**TECHNICAL BULLETIN**

**205-15-126**

**MODEL AFFECTED:** 205A/205A-1

**SUBJECT:** TAIL ROTOR GEARBOX INPUT QUILL LEAK,  
PREVENTION OF

**Figure 1**

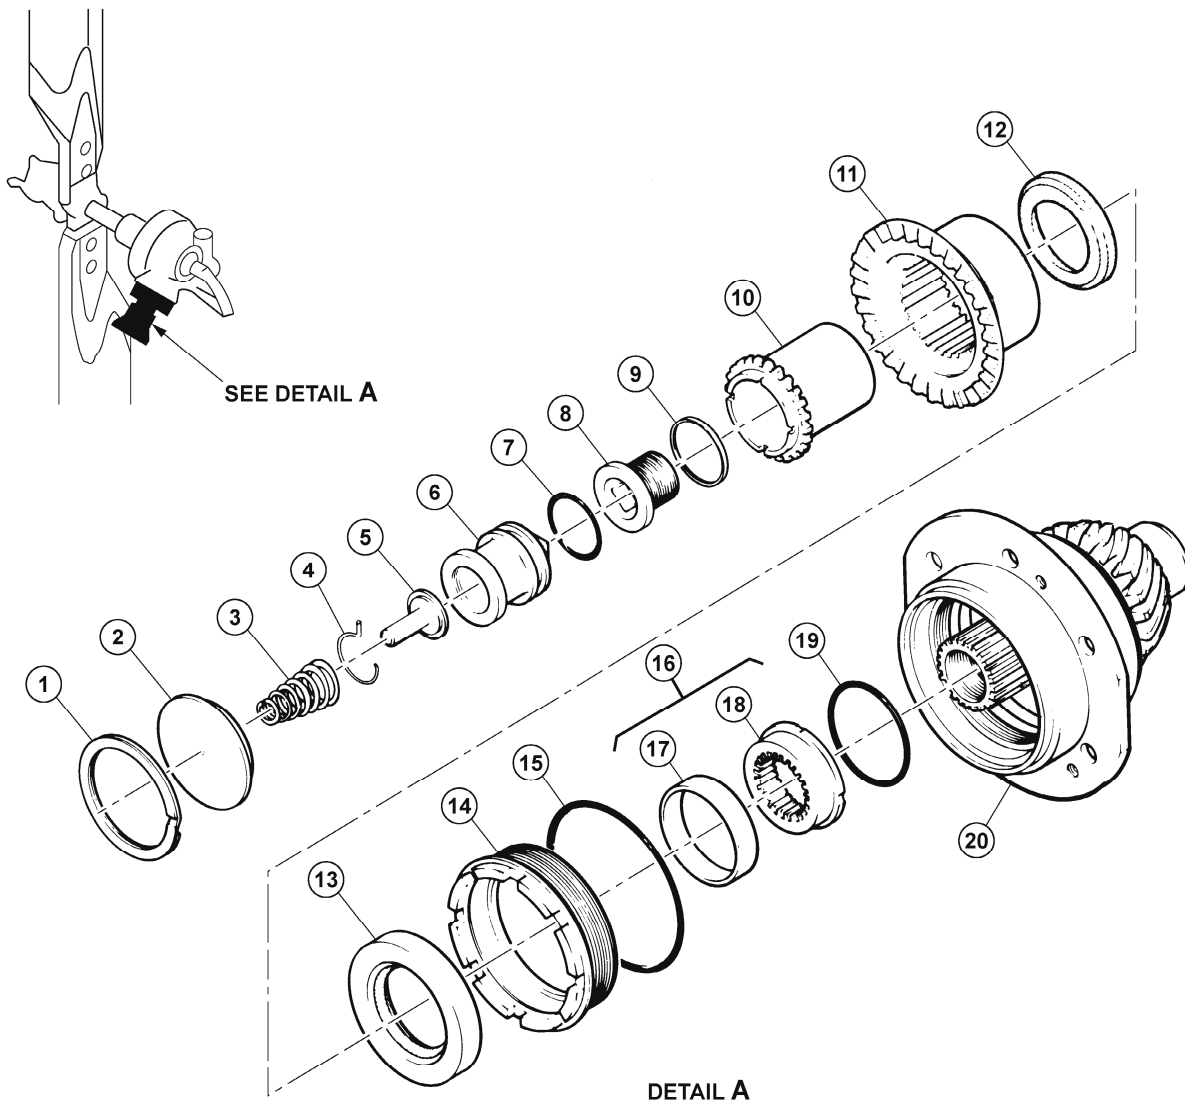
There have been some reported cases of oil leakage from the tail rotor gearbox input quill not caused by the seal. These occurrences have been noticed on both new production gearboxes and those with some time in service. The introduction of a revised spacer, along with the addition of a packing, will prevent the oil leakage between the spacer and the bearing. Applicability of this bulletin to any spare part shall be determined prior to its installation on an affected helicopter.

This bulletin provides the instructions to install the new spacer assembly 212-040-457-101 to prevent the oil leak between the spacer and the bearing.

1. Disassemble the tail rotor gearbox input quill to the extent necessary to remove the spacer assembly 212-040-457-001 (Figure 1, Item 16) in accordance with the BHT-205A1-CR&O, Chapter 65.
2. Install packing P/N AS3209-217 (Figure 1, Item 19) on the pinion assembly followed by the new spacer assembly 212-040-457-101.
3. Assemble the tail rotor gearbox input quill in accordance with the BHT-205A1-CR&O, Chapter 65.
4. Make an entry in the helicopter logbook and historical service records indicating compliance with this Technical Bulletin.
